Addendum No. 03

File Reference Number: RFP 2025 091

Title: LED Lighting Upgrades - North Bay Head Office

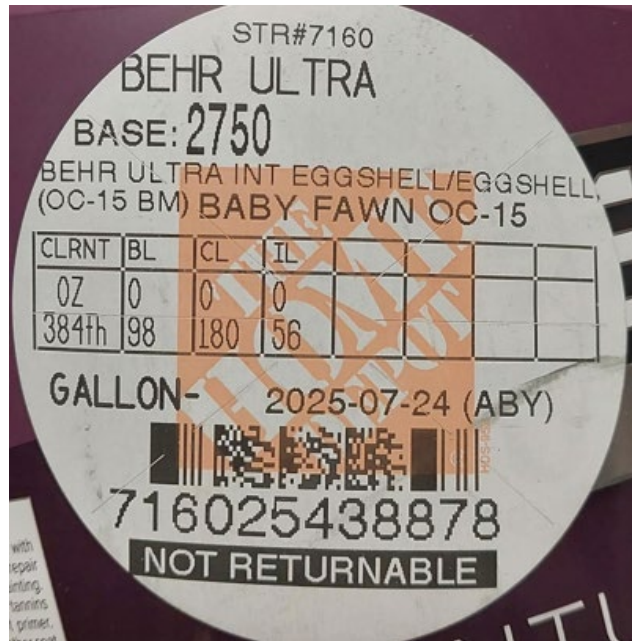
Item 9: Can ONTC please advise of the specification, colour and type of paint, if required?

Answer: ONTC advises that paint is to match the existing specification, colour and finish. Contractor to coordinate exact requirements on site. Please see image below for specifications. Colour name - Baby Fawn:
